IN THE MATTER OF: The Resource Management Act 1991
AND
IN THE MATTER OF: Applications by Central Plains Water Trust
to:

Canterbury Regional Council for resource consents to take and use water from the Waimakariri and Rakaia Rivers and for all associated consents required for the construction and operation of the Central Plains Water Enhancement Scheme.

BRIEF OF EVIDENCE OF RICHARD SPENCER ENGLISH

Graph 1: Waimakariri Flow Losses v Flow.

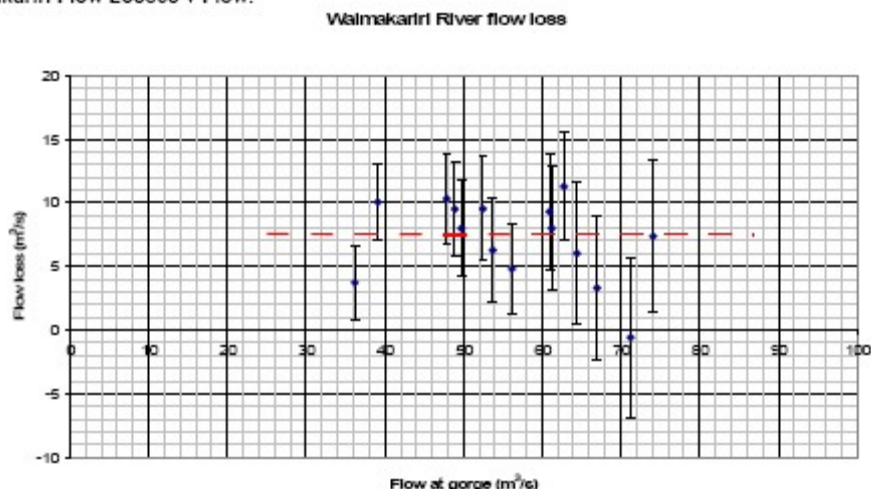
- 40 Clearly there are a scatter of results, however for the sake of simplicity the 'conventional' assumption has been to draw a horizontal straight line (shown red dashed) through the points - and hence the conclusion that flow losses are constant. This has given rise to the oft quoted loss from the Waimakariri being "7 to 8 cumecs" (Aqualinc have referred to this figure in their evidence as a partial validation of their model although it should be noted that they are not suggesting that the loss is constant.)

- 41 This is not an unreasonable conclusion to draw from the raw data although in my opinion it is a highly questionable one. Somewhat perversely for example, an inverse relationship could also be deduced such is the scatter of the results.

Graph 2: Waimakariri Flow Losses v Flow (Zero Flow, Zero Loss Point added)

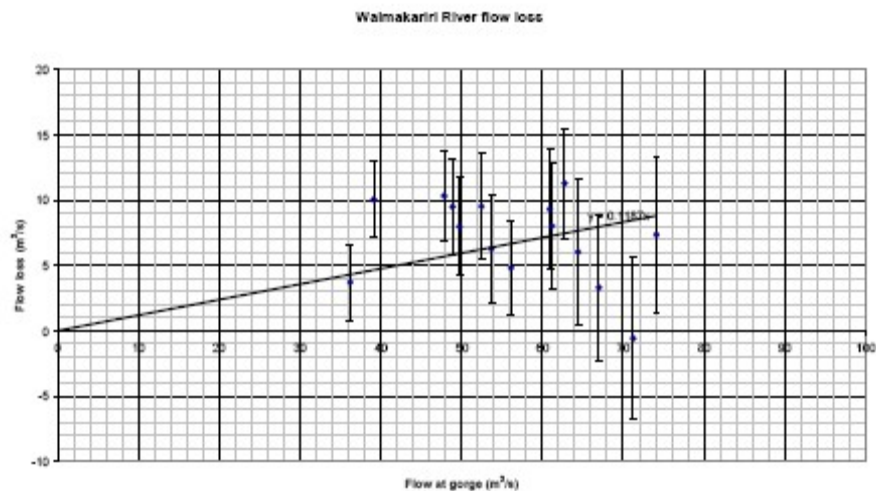
- 43 However the scatter of the results do not indicate a proven relationship particularly given the impact of these assumptions on the outcome of any modeling process.
- 44 It should be noted that these readings were only able to be taken at relatively low flows (i.e. between 30 to 80 cumecs) whereas the average flow in the Waimakariri is around 120 cumecs and flood flows can be of an order of magnitude or more greater. One would also therefore have to question how well the readings represent the flow / loss relationship under more average, rather than low flow, conditions.
- 45 In view of these uncertainties, their importance to the modeling process and the whole hydrological outcome of the CPWT Scheme, I have attempted to test the underlying assumptions by other means.

Graph 3: Waimakariri Flow Depth(Blue) v Aquifer Level at Mcleans Island (Red)

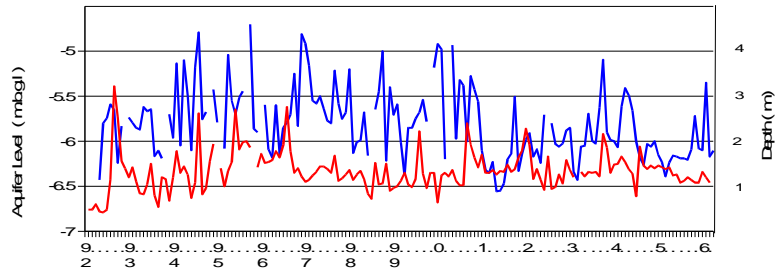
Only a weak relationship would appear to exist.

Graph 4: Waimakariri Base Flow (Blue) v Aquifer Level at Mcleans Island (Red)

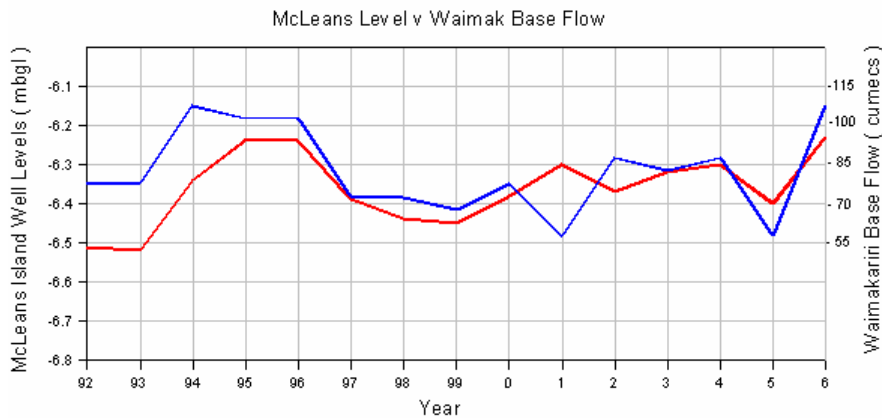
48 The monthly data for the 2006 has also been plotted. The relationship between base flows in the Waimakariri and aquifer levels at Mcleans Island is again observable.

Graph 6: Waimakariri Base Flow v Aquifer Level at Mcleans Island

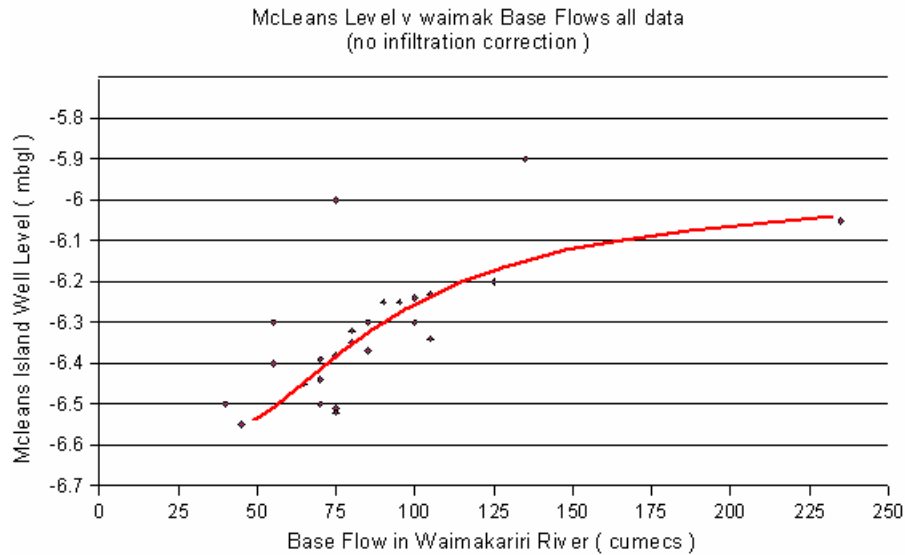
- 50 It is clear that there is a correlation between (at least base) flows in the Waimakariri and aquifer levels at Mcleans Island.

- 63 Summarising the information from Graphs 6 and 7 it can be seen that there is a clear relationship between:
- River flow and levels in the adjacent aquifer, and

Graph 7: Mcleans Island Aquifer Levels v Measured Flow Loss from Waimakariri

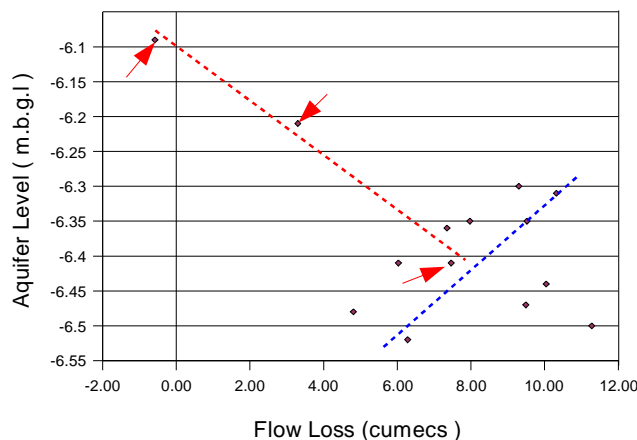
- 53 Coincidentally the arrowed data point measurements were taken when the river was flowing at effectively the same rate on each occasion. It can be seen therefore that when the aquifer levels were high because of rainfall infiltration the flow losses were much less than for the same flow without infiltration impacts.

- 54 It would appear, for example, that at average base flow, a "back pressure" created by a rise in aquifer level of about only 300mm is sufficient to reduce leakage from the river to zero.

- 56 It would appear significantly, therefore, that the quantum of the flow loss is very sensitive to the level of the adjacent aquifer.
- 57 NIWA have undertaken modeling work on the river's hydraulics by developing flow / depth and flow / width relationships. The results may be found in Greg Burrell's Response to Section S42A Officer Reports. (I am unfortunately unable to reproduce the data here as the document is copy protected)

- 95 Referring to Graph 7 it can be seen that if aquifer levels at Mcleans Island are raised by 0.25m, for reasons other than increases in flow in the river, average flow loss from the river will drop from approximately 9 cumecs to approximately 2 cumecs.

Graph 8: Derived Waimakariri River Flow Loss v Flow

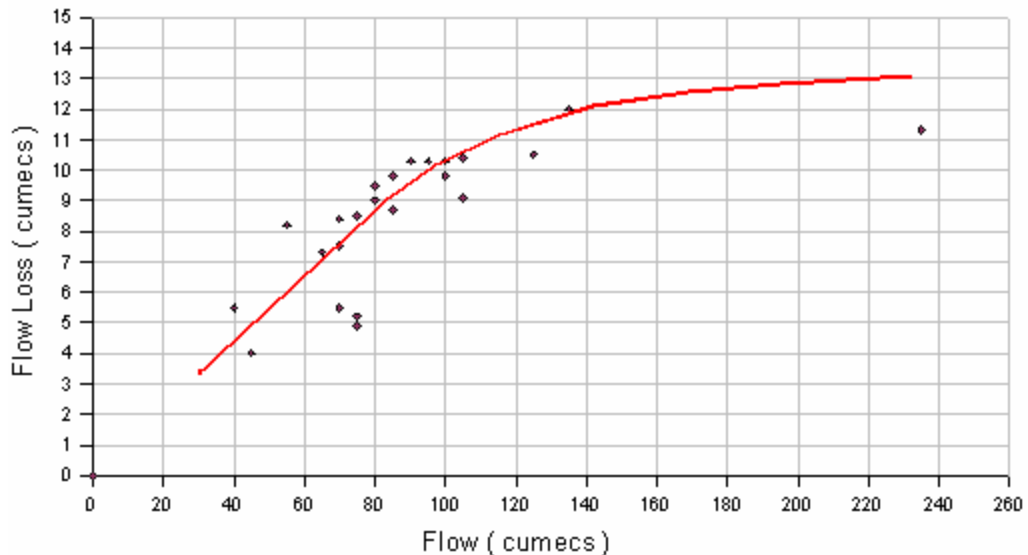
70 In this case I believe that the asymptotic nature of the curve in Graph 8 shows that flood events have the ability to provide recharge at a rate greater than the aquifer can carry it away, particularly in the short term, and hence the reduced correlation between adjacent aquifer levels and average flows in comparison to aquifer levels and base flows.

- 92 Referring to Graph 8, using an initial average base flow in the river of 80 cumecs the average loss / recharge from the river would be of the order of 9 cumecs.

- 93 Aqualinc have predicted that the average flow in the river will decrease by approximately 10 cumecs. once the CPW scheme is operational.. Again referring to Graph 8 it can be seen that at 70 cumecs the flow loss will be approximately 8 cumecs (i.e. approximately 1 cumec less than the pre CPW situation) The decrease in loss is similar to that postulated by Aqualinc (refer para 80 above)
